April 12, 2017

RE: RESPONSE TO REVIEW COMMENTS  
LOT 9, CUMBERLAND FORESIDE VILLAGE

CUMBERLAND FORESIDE VILLAGE LOT 9  
U.S. ROUTE ONE, CUMBERLAND, MAINE

FRONT ELEVATION  
Parking Lot Elevation

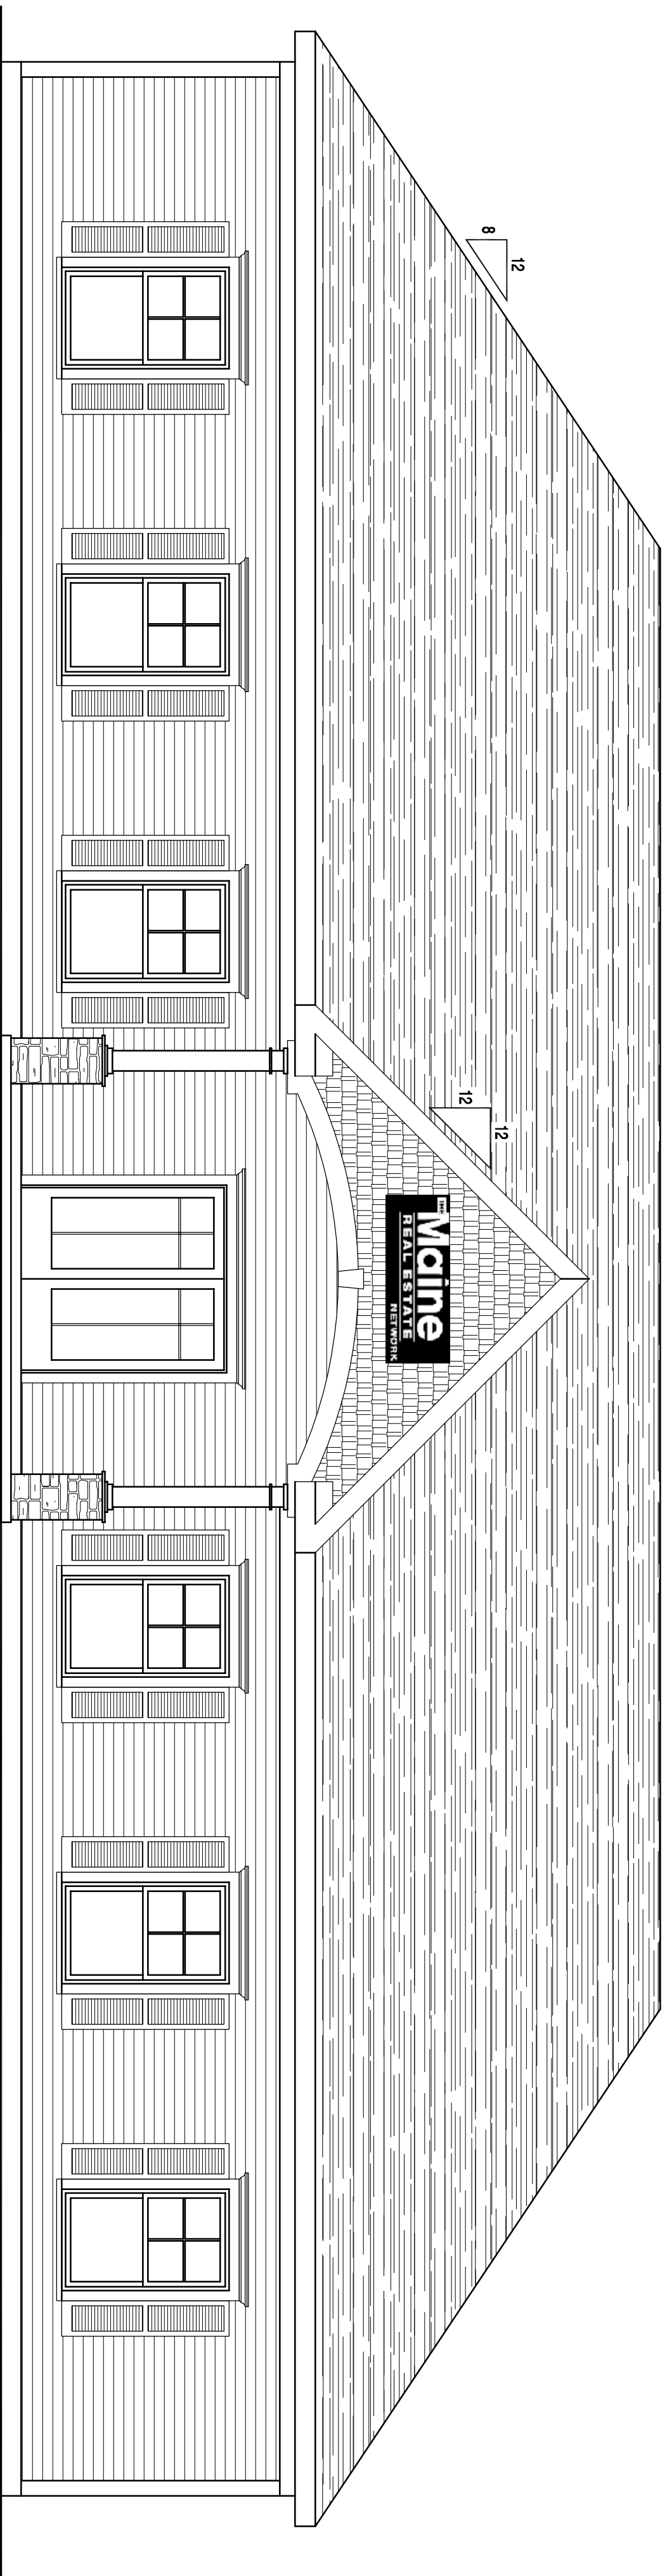
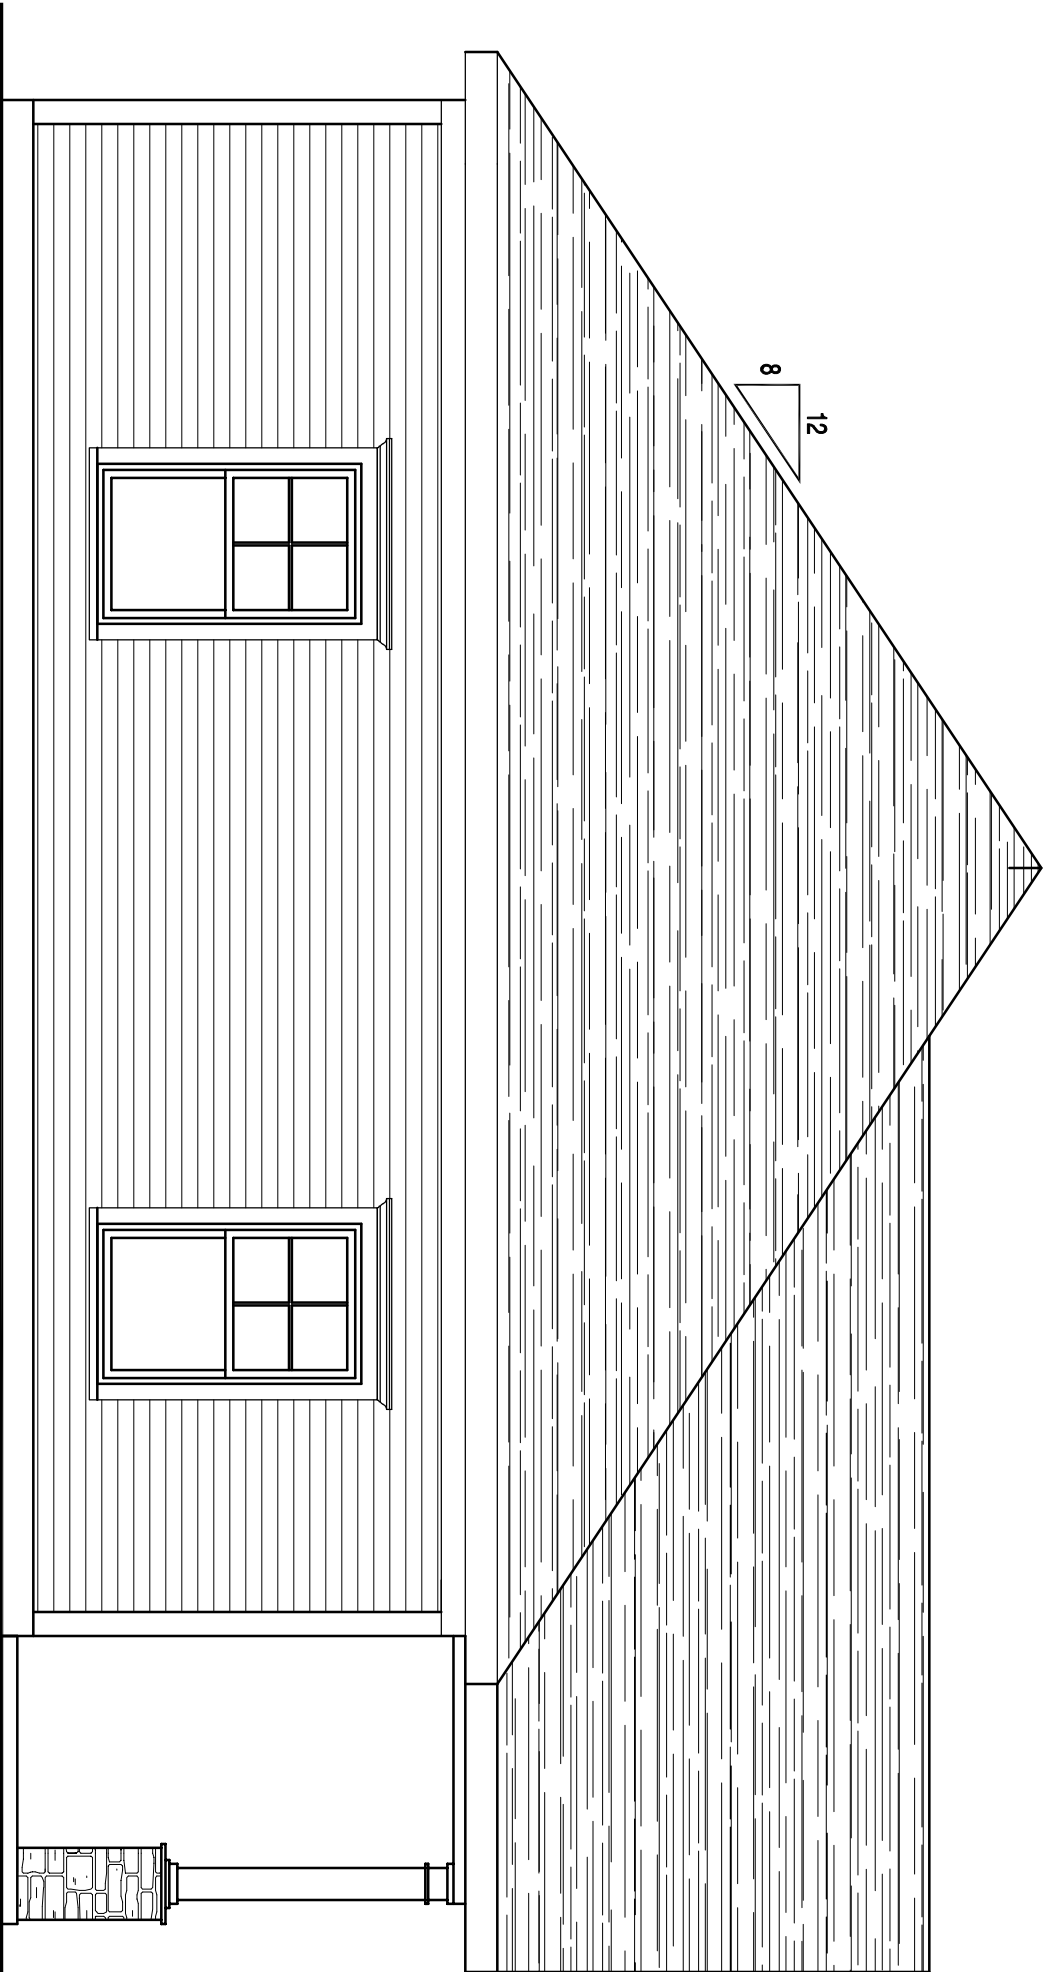
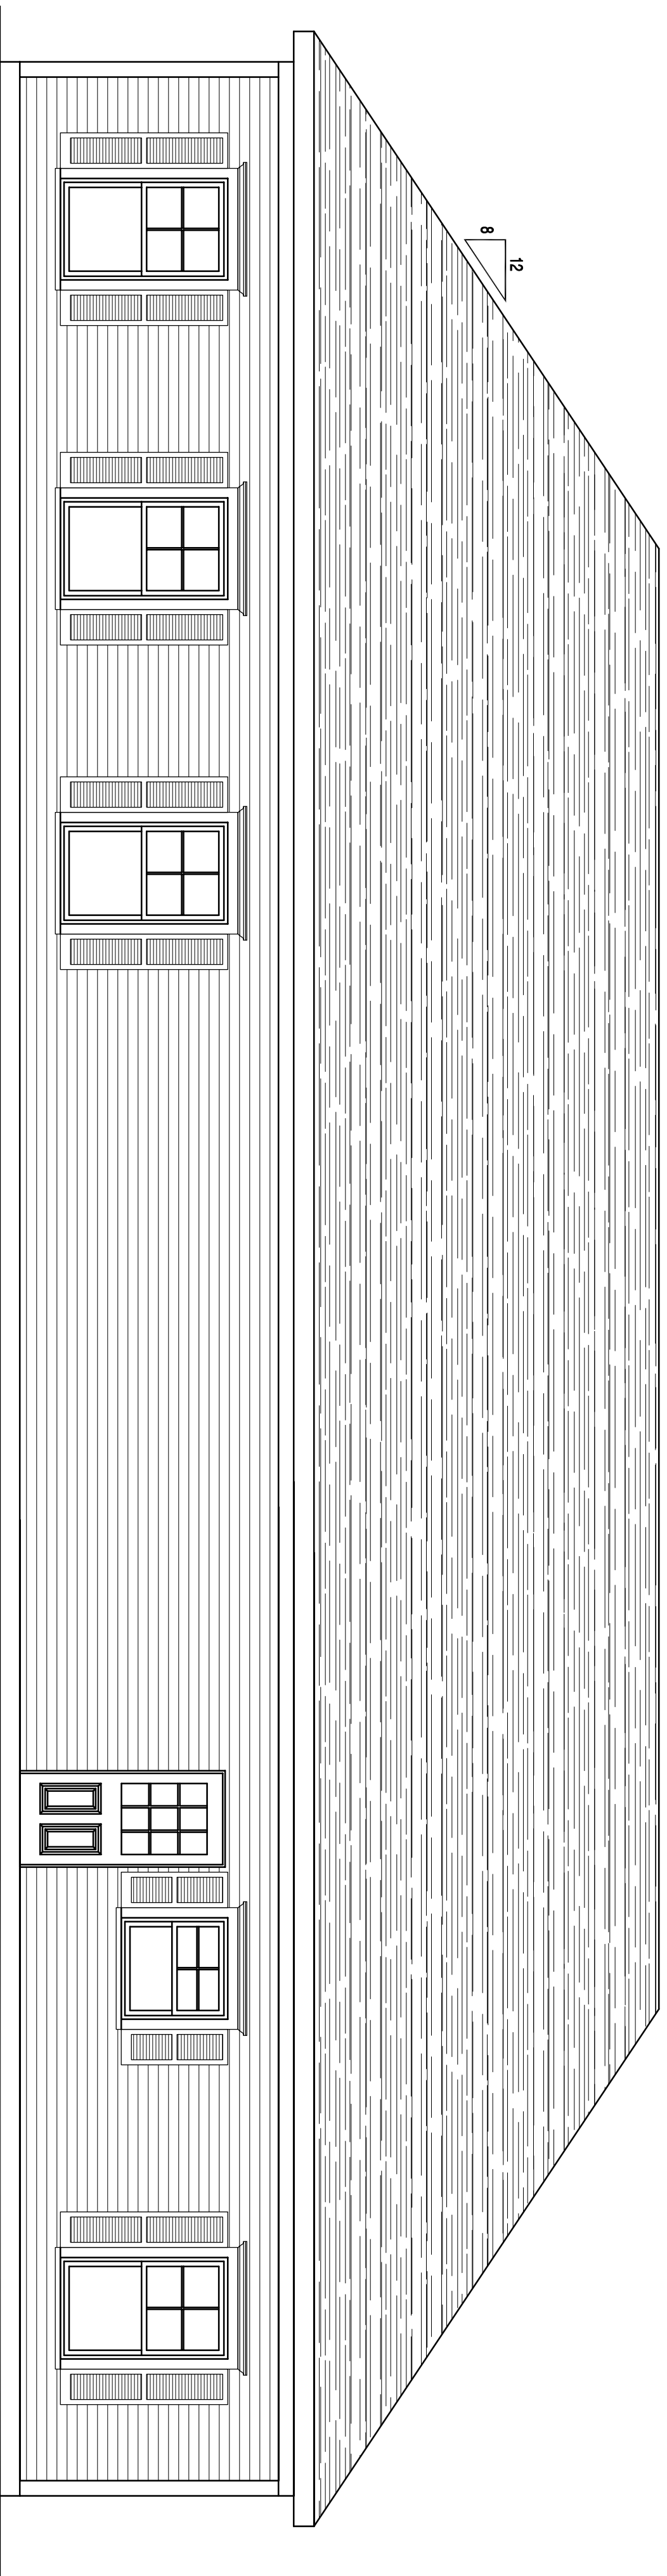
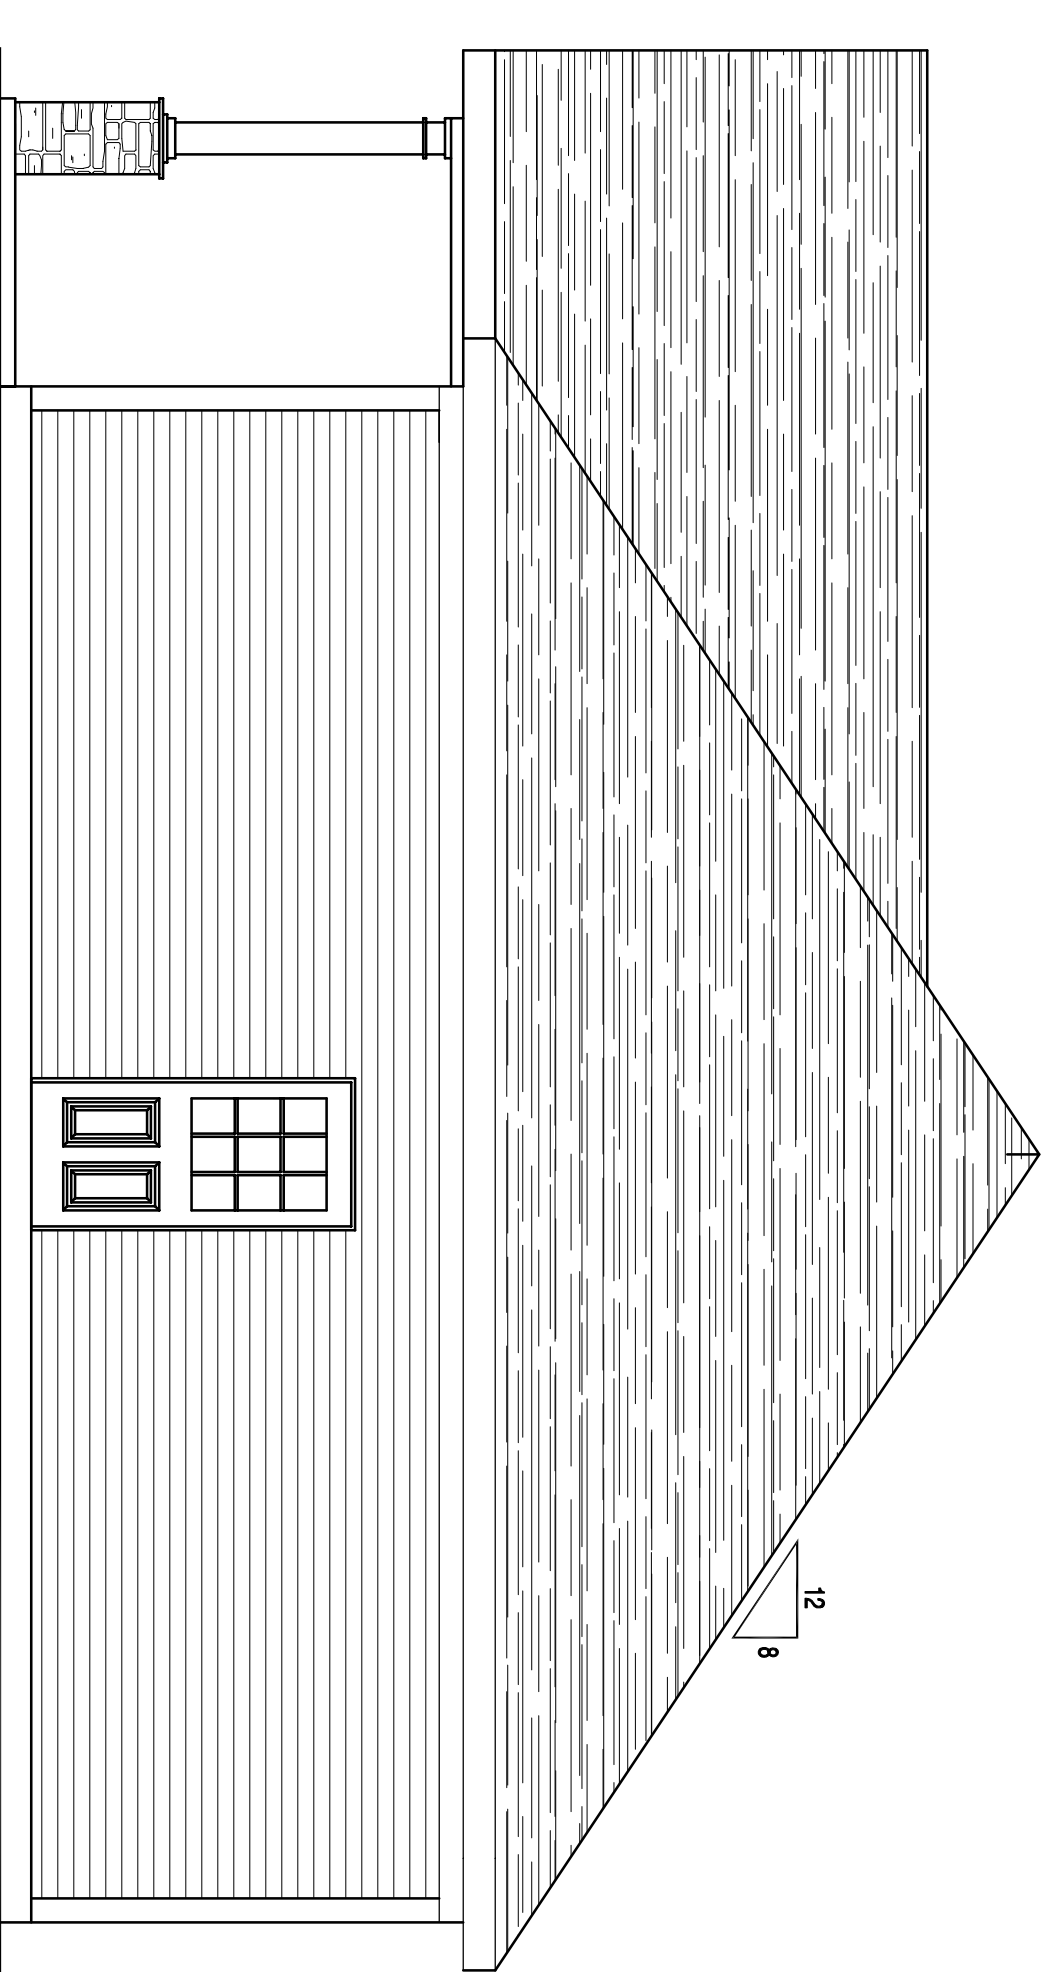
5. We have shown the path along Route 1. It is to be placed to avoid any trees if possible. A detail is added to Sheet C2.4.
6. The building elevation orientations have been clarified.

11. We have added the color scheme to the drawings of the building elevations.
12. We have shown the proposed sign location on the plan. If we can get a license from MDOT, we would like to place it in the right-of-way. The right-of way in this location is extra wide, so locating on the site doesn't provide any visibility.

BUILDING SIDING TO BE WHITE VINYL CLAPBOARD
